B. Mandatory Referral No. 2012026: Clarksburg Cluster Elementary School Clarksburg Village Site No. 1

B. Mandatory Referral No. 2012026 **Clarksburg Cluster Elementary School** Clarksburg Village Site No. 1:

Staff Recommendation:

Approval to transmit comments to Montgomery County Public Schools

Proposed Site Plan

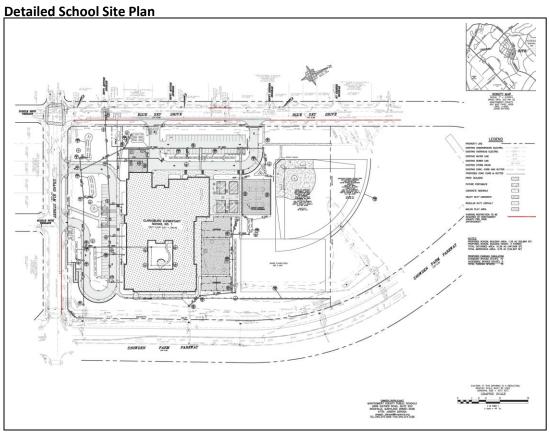
The site plan, including the School and Park sites, currently locates a large softball field north of the School facility with two adjacent fields, one to the north on the Park site, and one to the east of the softball field on the School site. The softball field is shown as overlapping the Park dedication line with the adjacent playfield to the east entirely located on the School site. The MCPS and the Department of Parks are currently working together to finalize the locations and designs of all of the playfields. The MCPS and Parks staff will assist in determining a final coordinated design for both sites.

Discussions for the final location of the softball field include an option of moving the field to be located entirely on the Park site and relocating the playfield currently shown on the Park site to the south of the relocated softball field.

For determination of final construction plans for the recreation fields at both sites, MCPS and the Parks Department have agreed to work together to implement the best design for shared use of the outdoor fields at both sites. On September 14, 2012, MCPS submitted a statement to emphasize the cooperative effort as follows:

- Agreement between MCPS and the Department of Parks (M-NCPPC) on final Ballfield layout on Park property
- Montgomery County Public Schools (MCPS) will work cooperatively with the Department of Parks (M-NCPPC) to develop the final site plan for the shared use of the School/ Park site. The final shared-use site design will be agreeable to both parties prior to issuing of the Department of Parks permit for construction.
